## **Hillmont**

Applicant drawings dated 09-05-23

Design Comments

Prepared by: Brian Peterson, AIA, Urban Designer, T.O.C.H.  
09-21-23

# Diagram 1

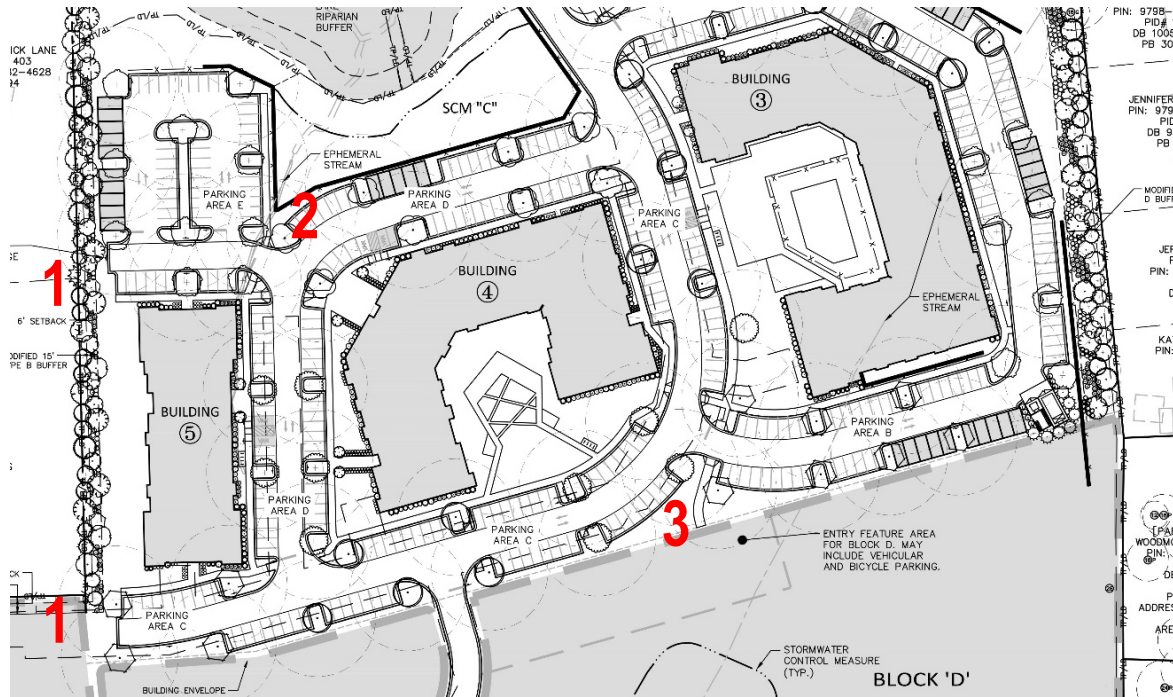
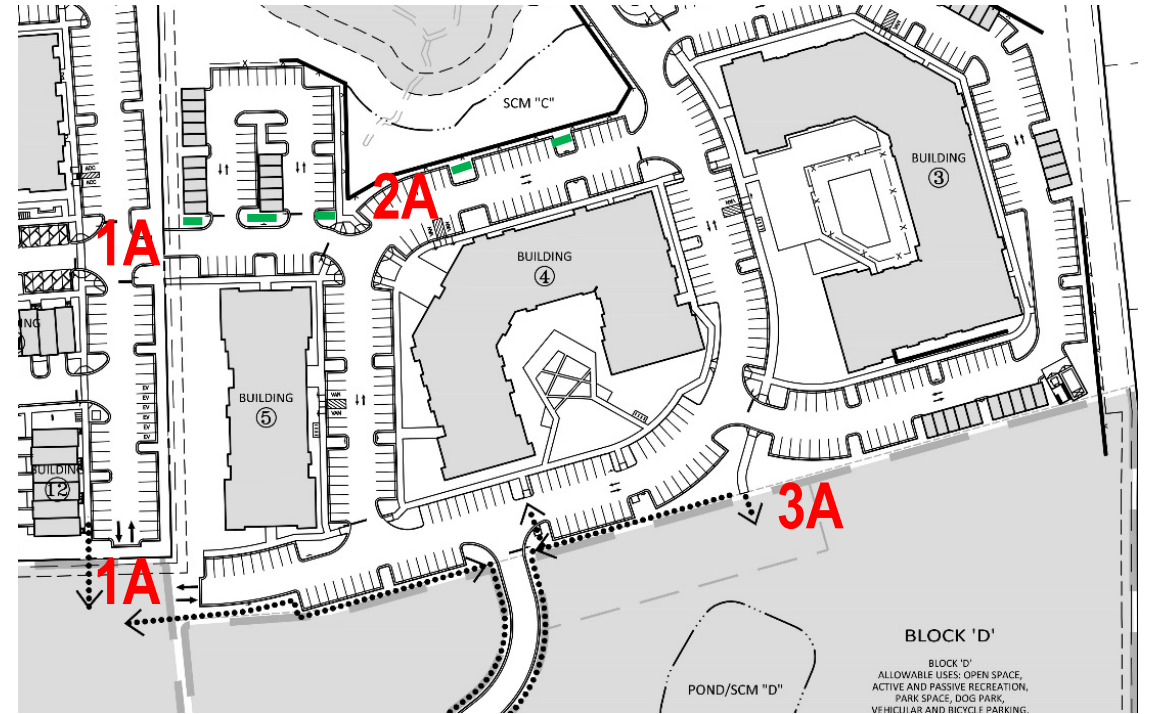
1. Two important locations for street and sidewalk connections into the Barbee Chapel Road (BCR) multi-family project are not indicated. Street connection is vital to the integration of the two projects.

3. Consider ways in which to make the main pedestrian entrance to the proposed central park into a more visible and welcoming place.
  - 3A. Per suggestion, the bump outs where the multi-use pathway crosses into the park have been widened on both sides of the street, providing more area for plants and other landscape features which could help create a sense of entrance.

- 1A. The intention to connect the streets and sidewalks has been verified, at both locations. Both property owners have worked to coordinate this.
2. The street/parking frontages along this segment need improvements to enhance the landscape and streetscape character as well as to provide some continuity with BCR.

- 2A. The garages which had previously been located along the northern edge of the parking have been relocated to an off-street location in the parking lot near the RCD/stormwater area. Five trellis/ pergola features (green lines on Image 2) have been added, per suggestion, to provide vertical and space defining elements along the northern edge of the frontage, and to add some scale to the parking area. Landscape bump outs in the parking areas have, in some cases, been realigned, to match locations across the street to give better rhythm to the landscape character. Bump outs at the southern end of the garages have been enlarged to provide more room for landscape between the street and the garage edges. The sidewalk location will be on the south side of the street, which is where the sidewalk connection to BCR is proposed.

Image 3: Urban Designer  
Additional Comments on 09-05-23  
Plan

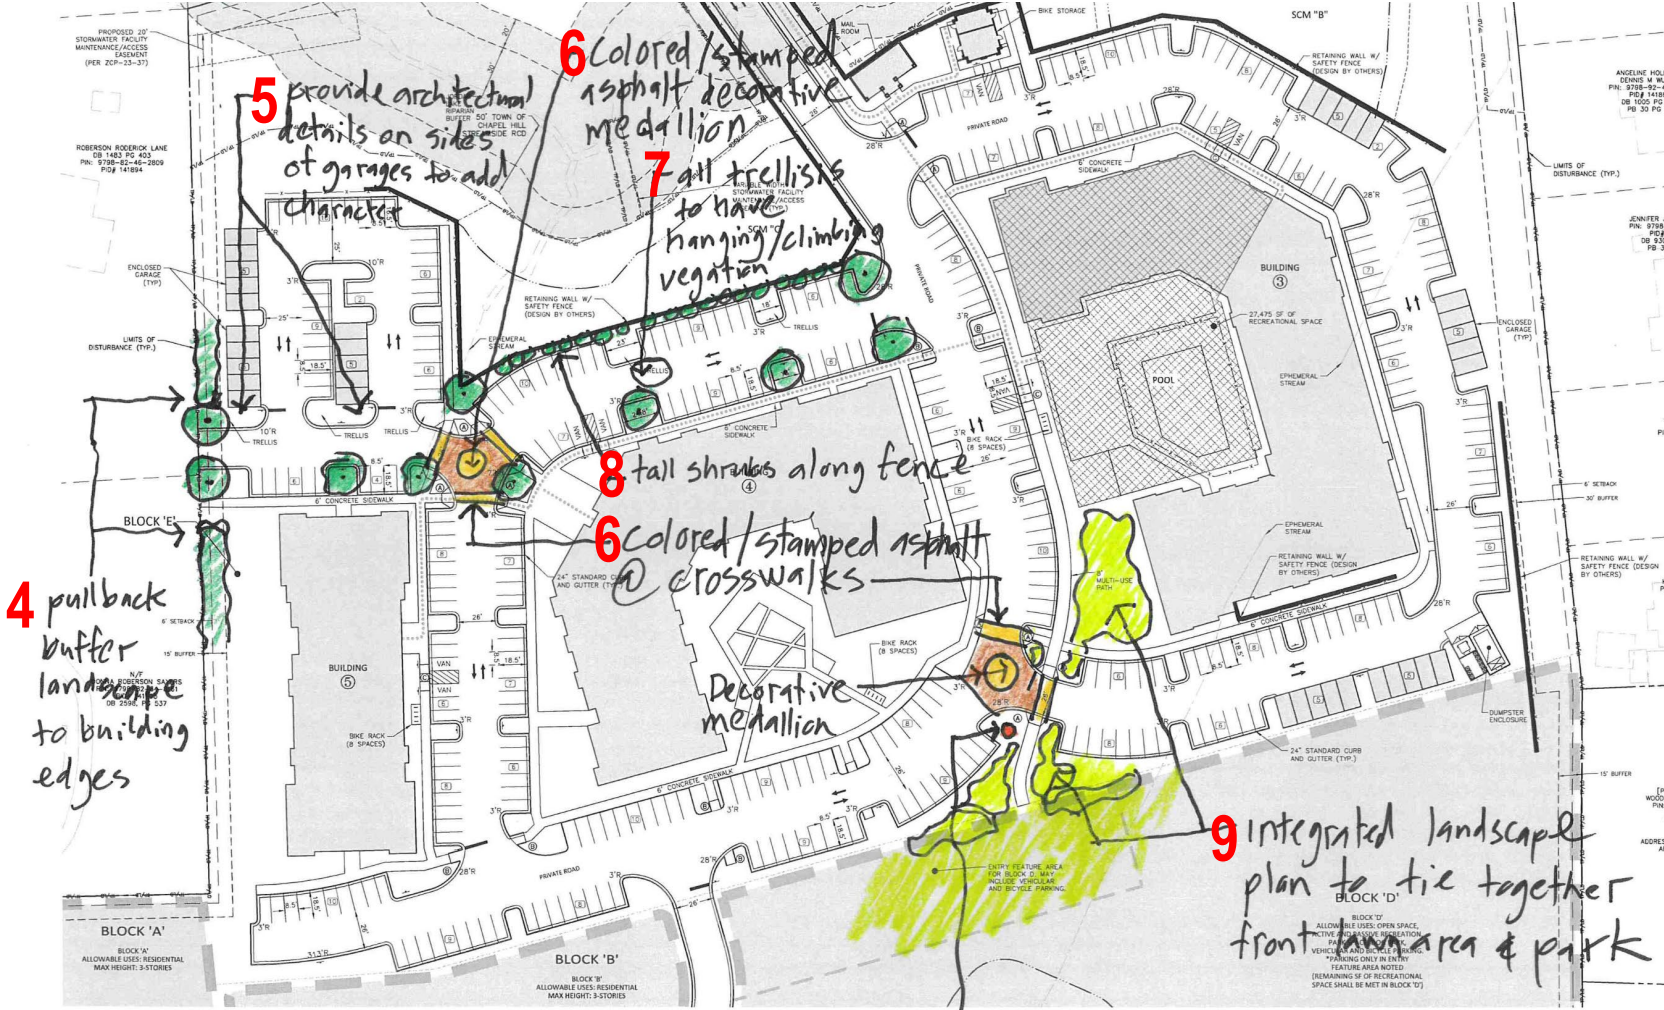
4. Pull back the buffer landscape to align with the building edges, to provide for visual connectivity along the street between the two developments.
5. Provide architectural details on the side elevations of the garages along the street to add to the streetscape character.

6. Provide colored/stamped asphalt, or other paving enhancements, at the intersection in the form of crosswalks and a decorative medallion. In addition, consider a similar treatment at the entrance area to the neighborhood park. Another location which was discussed included the main entrance point for the project, just south of Stancil Drive.

7. All trellis/pergola structures should have hanging/climbing vegetation to create a “green wall” effect.
8. Provide tall shrubs or small trees between the fence and the edge of the parking, to enhance the streetscape/landscape character.

9. Create an integrated landscape approach to tie together the front lawn area in front of Building 3 and the neighborhood park into one coherent entrance experience into the park.

10. In this portion of the park entrance, consider placing a vertical landscape element, architectural feature, or sign to act as a view terminus from the main north/south street, and to help establish a “gateway” into the park.

Vertical park element to create focal point at street view terminus and "gateway" into park
